ADDENDUM NO. 03

PROJECT: Cosmos Educational Learning Center

**ADDENDUM (ADDN) NO. 3
TO PLANS AND SPECIFICATIONS FOR:**

**COSMOS EDUCATIONAL LEARNING CENTER
COSMOS, MN
STEEN #HDA201802**

SHEET TITLE:
HYDRONIC PLAN - AREA B

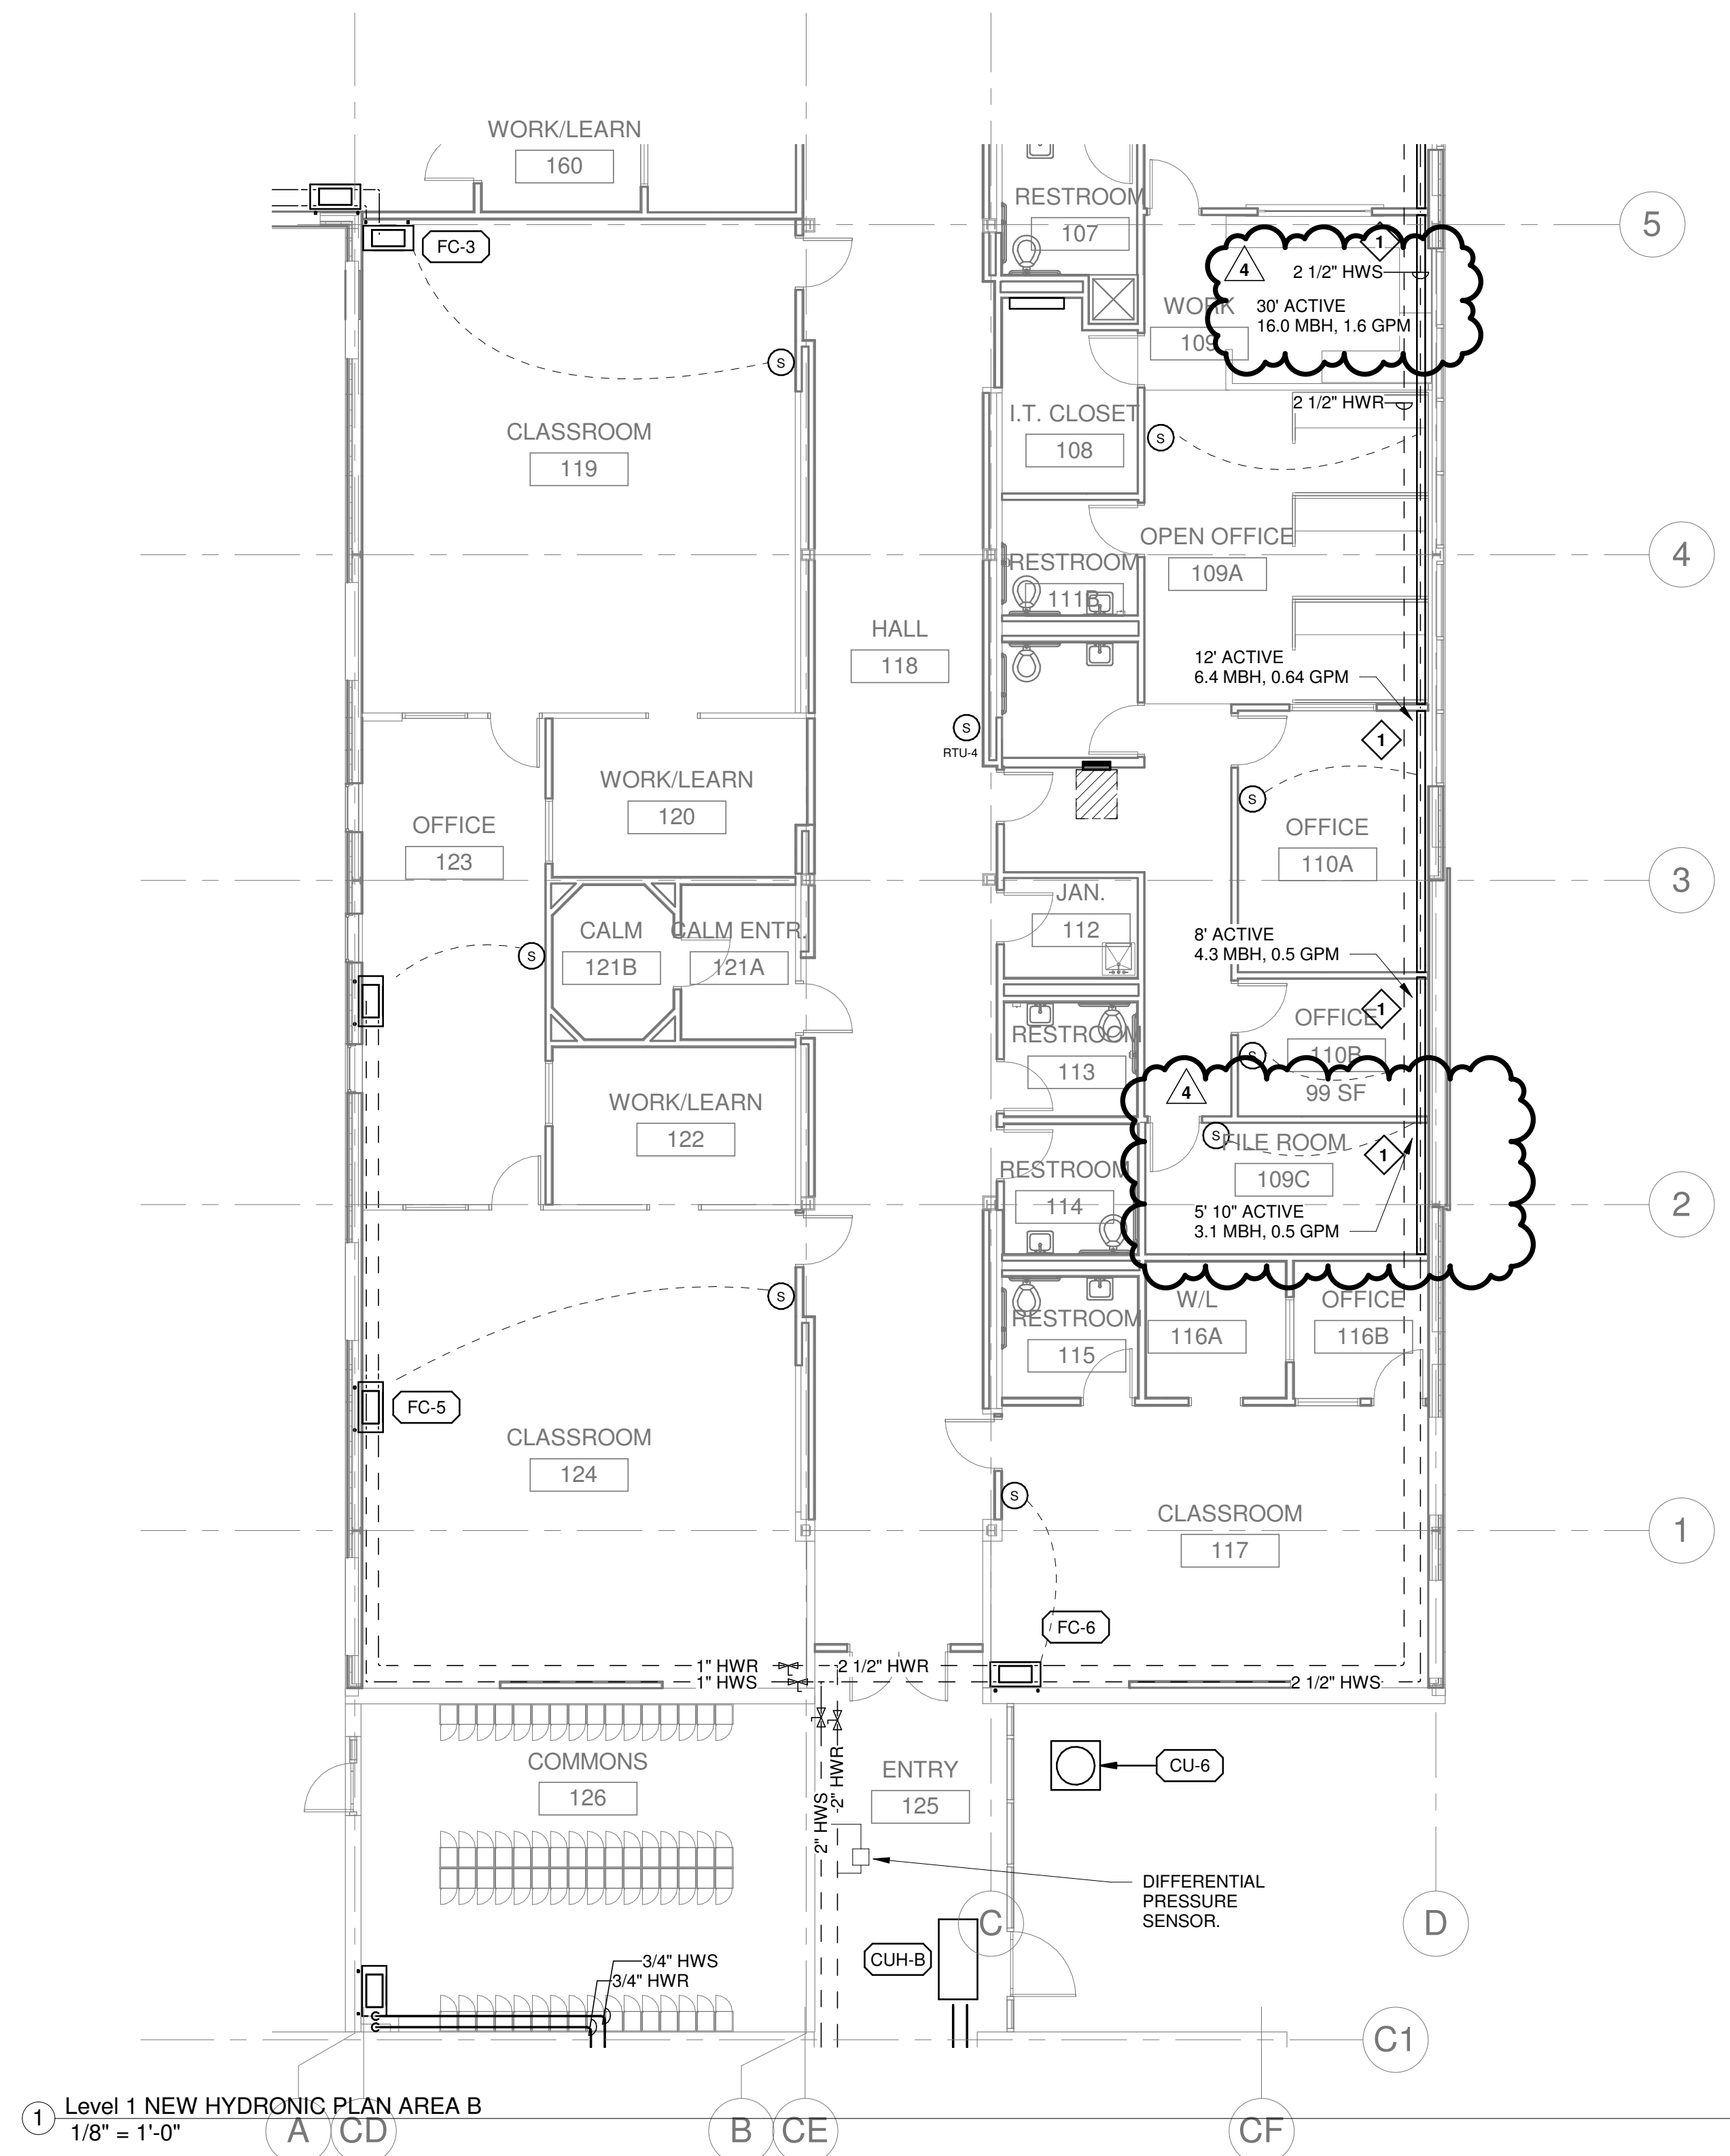
M400B Hydronic Plan – Area B: Revised and reissued (attached).

1. Revised FTR length, capacity and GPM in Work 109.
2. Added FTR valve and capacity data for File Room 109C.

SHEET TITLE:
HYDRONIC PLAN - AREA D

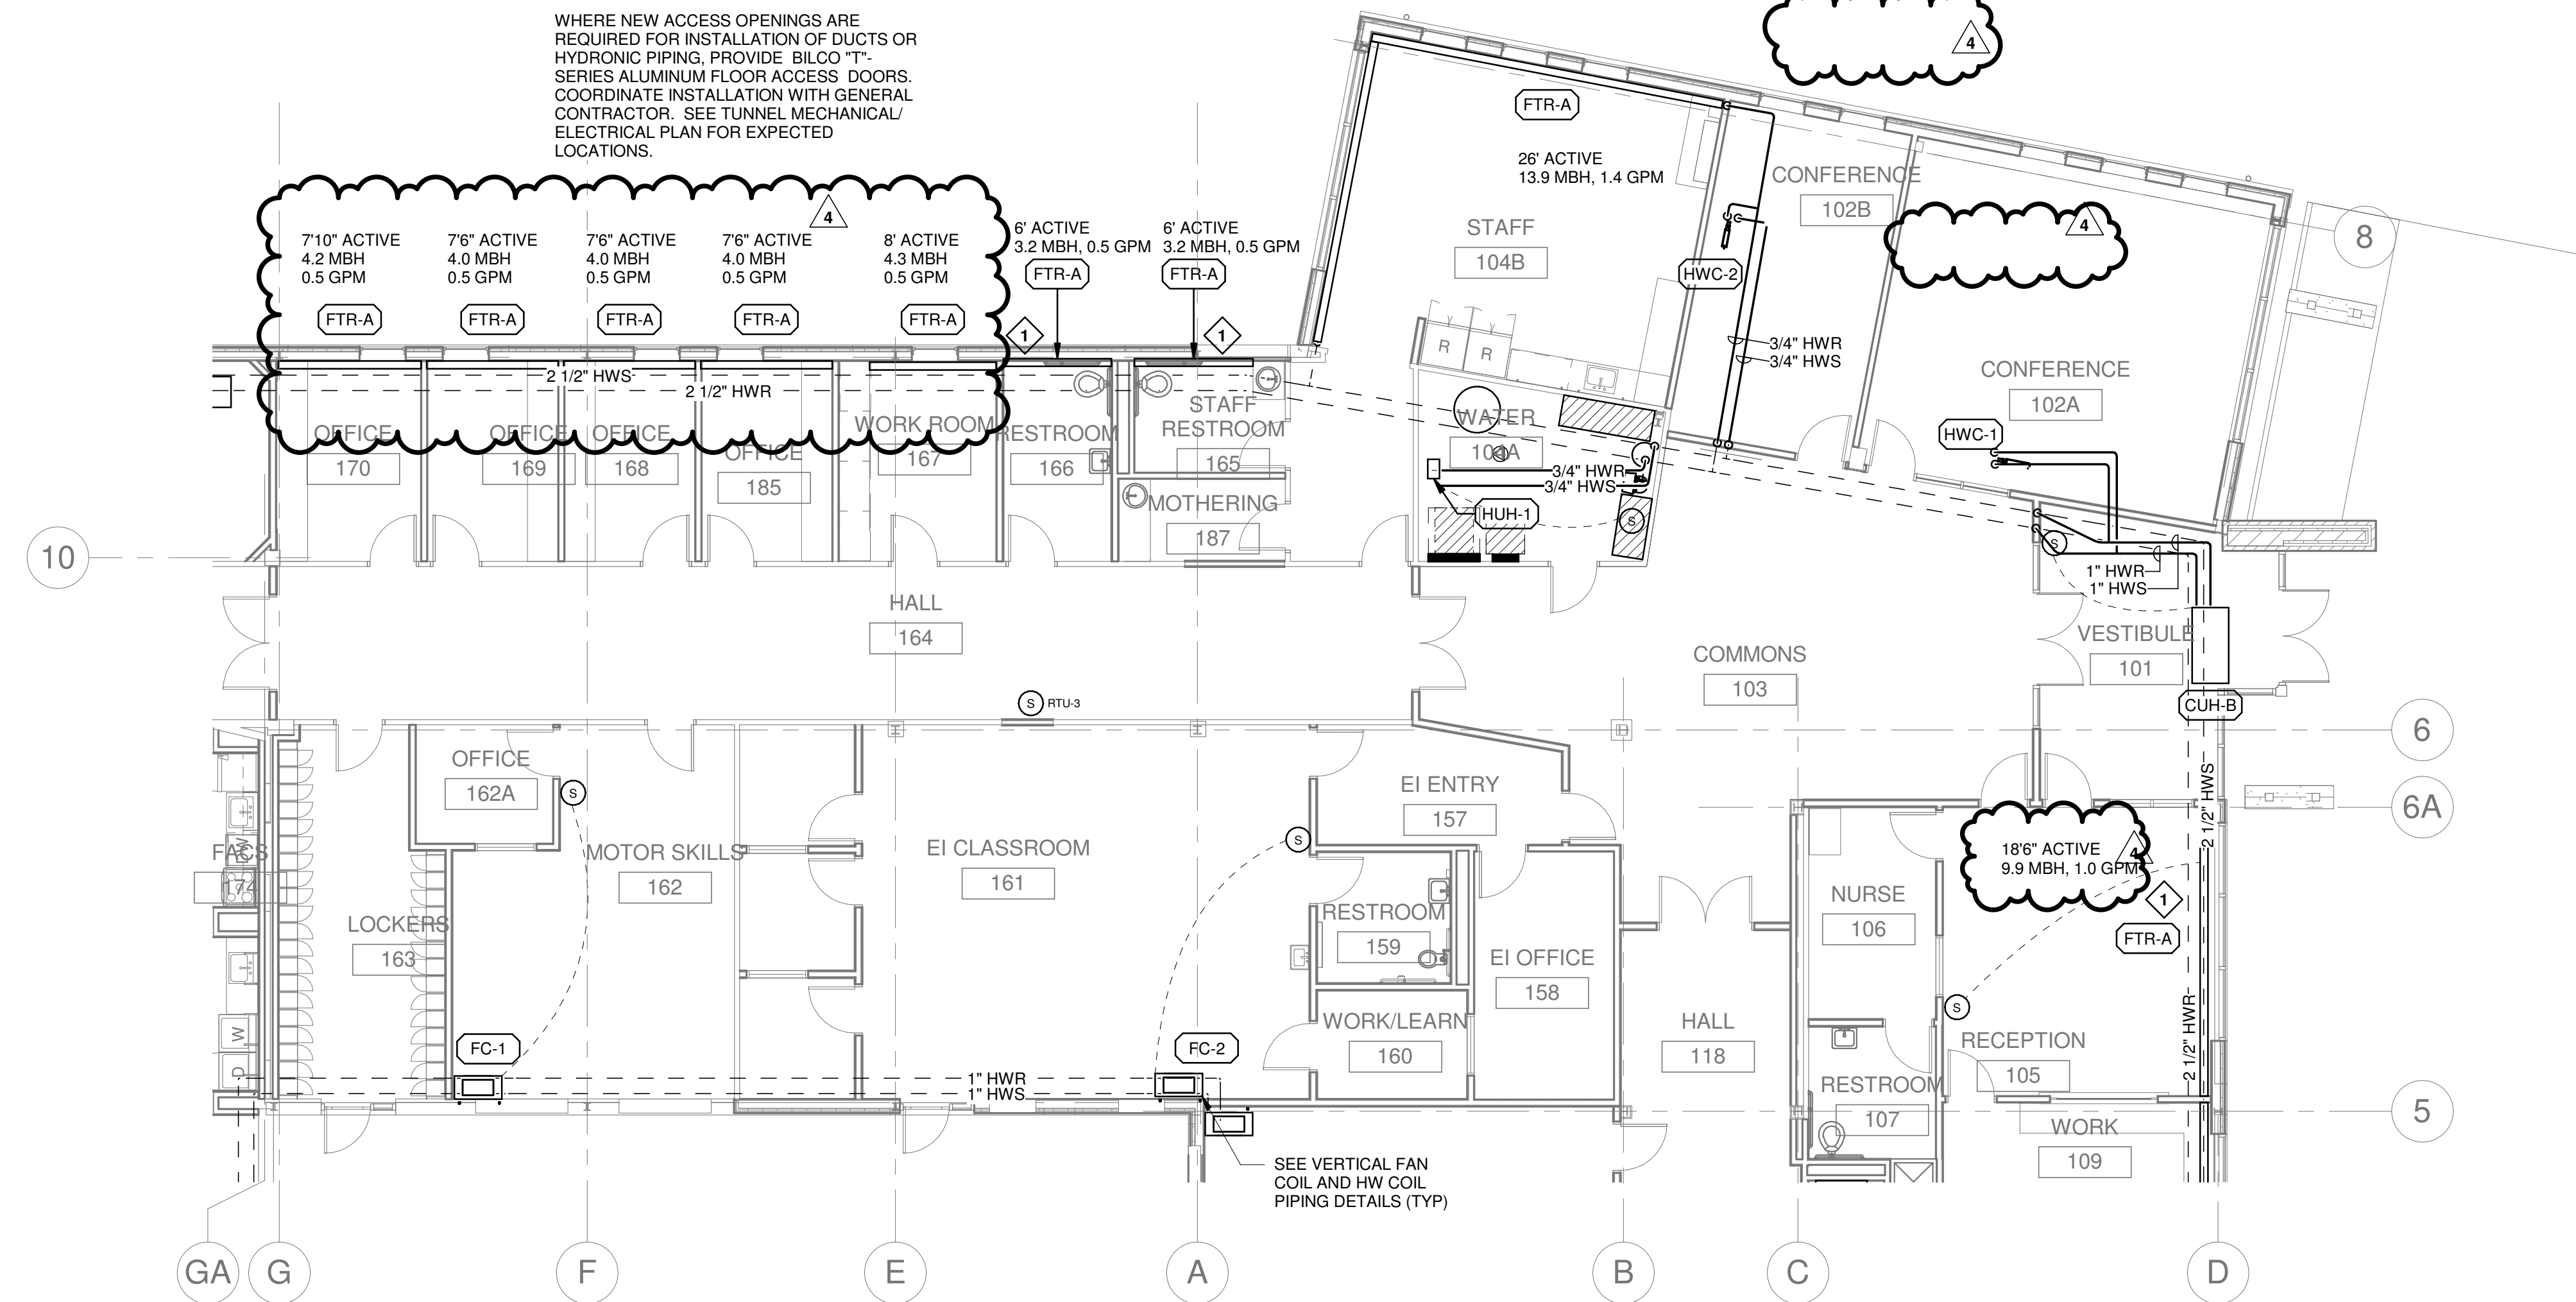
M400D – Hydronic Plan - Area D: Revised and reissued (attached).

1. Deleted notes for FTR in Rooms 102A and 102B.
2. Added FTR in Rooms 167, 168, 169, 170 and 185.
3. Changed FTR length in Room 105.
